Memo

Application: Z09-0062 (AB)

Subject: Rezoning Application

Date: December 1, 2009
File No.: Z09-0062
To: Land Use Management (AB)
From: Development Engineering Manager
Subject: W of South Perimeter Way

FIGURE 3
Proposed Development Area and Recommendations

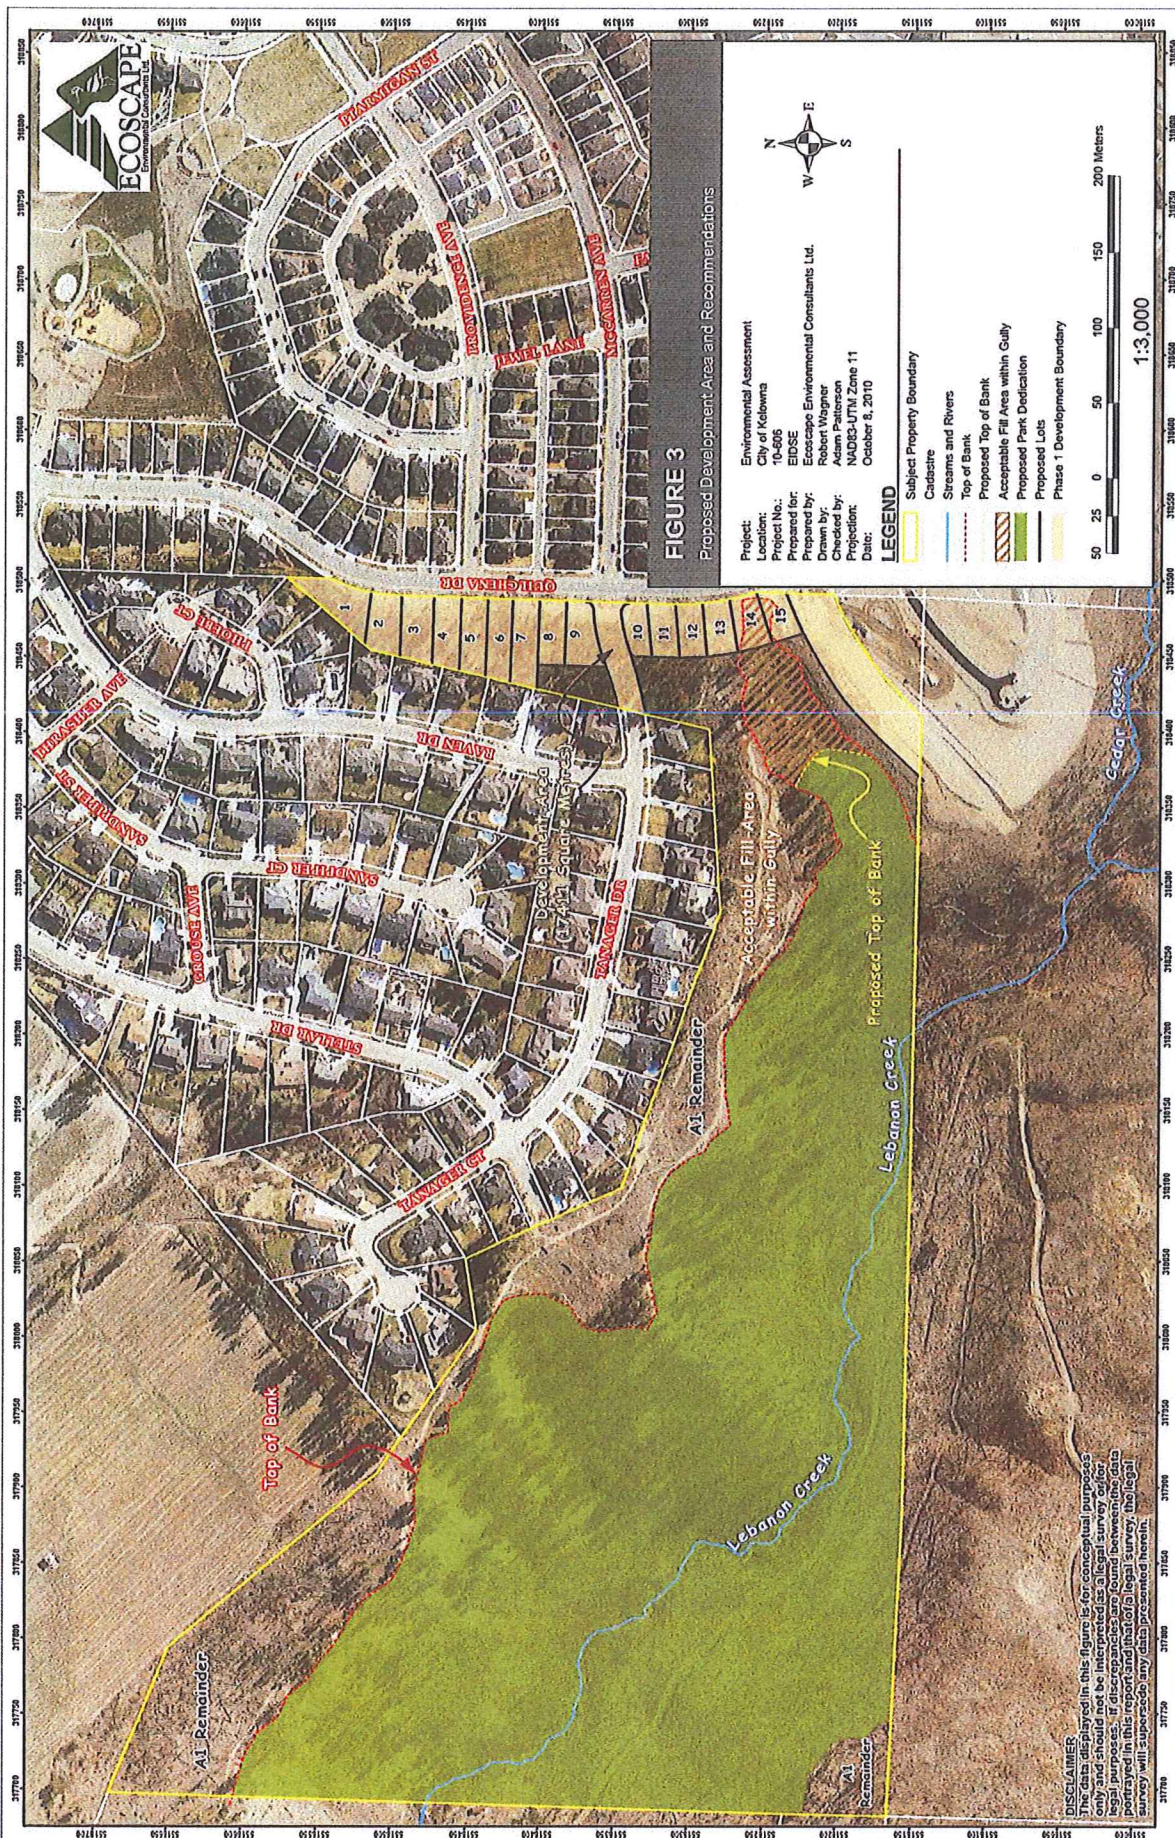
The report notes that the Lebanon Creek Top of Ravine was determined using a combination of existing SHIM (Sensitive Habitat Inventory Mapping) data and legal survey data, which was then field checked using GPS during the site assessment. Ecoscope concluded that the proposed 15-lot subdivision along Quilchena Drive is not expected to cause adverse environmental impacts to the proposed park, and went on to recommend various wildfire mitigation, weed management, restoration, and sediment and erosion control measures to be implemented during the subdivision process.
